UNITED STATES PATENT AND TRADEMARK OFFICE

APPLICATION NO.	FILING DATE	FIRST NAMED INVENTOR	ATTORNEY DOCKET NO.	CONFIRMATION NO.
10/802,194	03/17/2004	Roman Heckt	10541-1989	3418

Office Action Summary

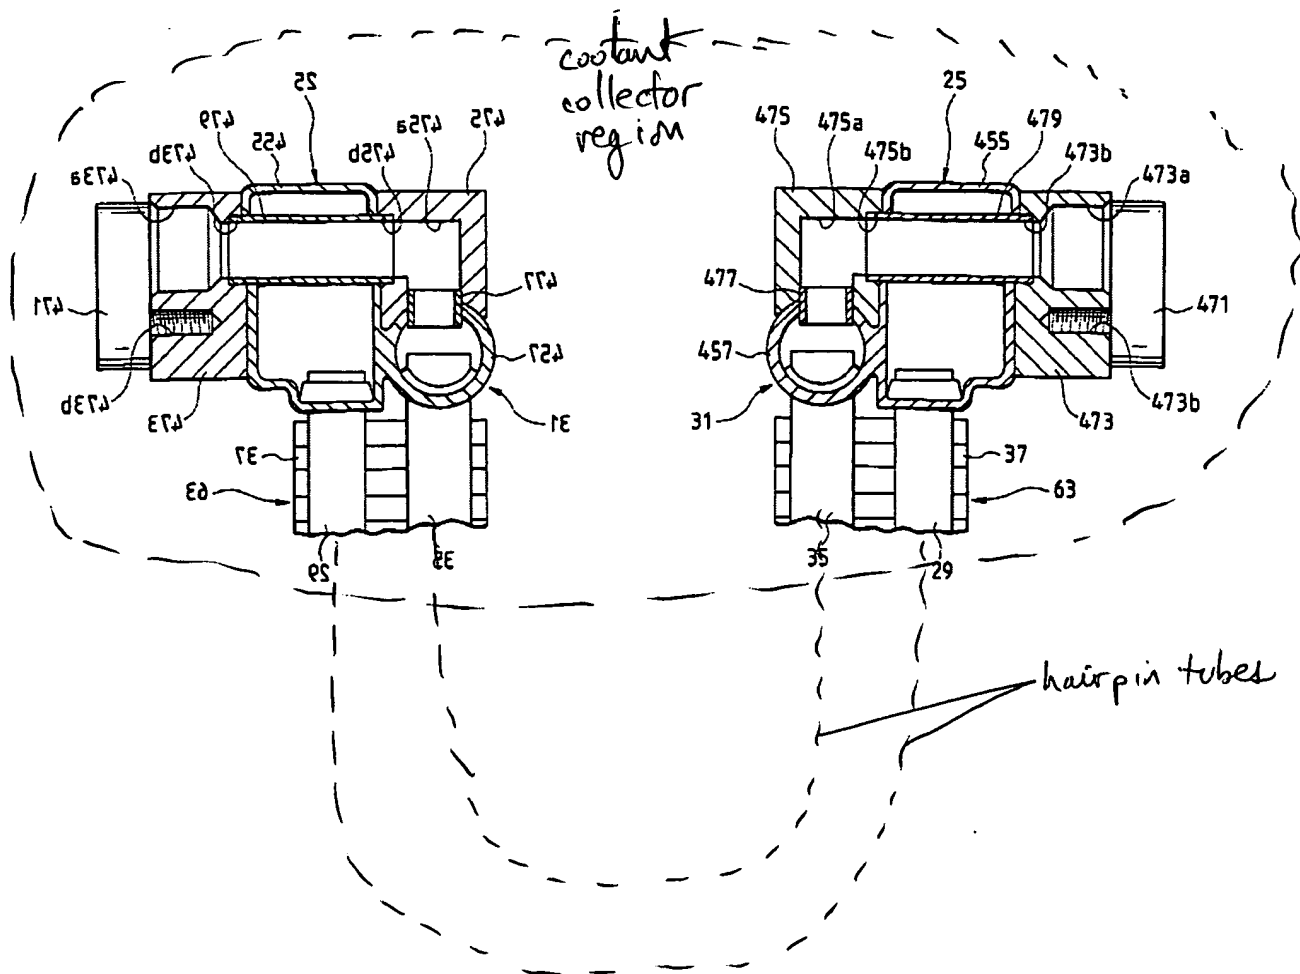
By comparison of Figure 3 of McKibben, that discloses a "straight-through" heat exchanger with headers 13 and 14 at opposite ends (similar to what Makino shows in Figures 24-27), and Figure 5 of McKibben (showing a "hairpin type" heat exchanger with both headers 22 and 25 adjacent one another at one end of the heat exchanger), the art recognized equivalence of these two types of heat exchangers is established. To have made the tubes 35 and 29 in Makino Figures 24-27 as the "hairpin" type rather than the "straight-through" type would have been obvious to one of ordinary skill in the art to advantageously fit the heat exchanger in a smaller air duct. As such, the inlet header and outlet header (depicted in either Figures 24 or 27 of Makino) would be located at the same end of the heat exchanger denoted for purposes of rejection the "coolant collector region." See the illustration below.
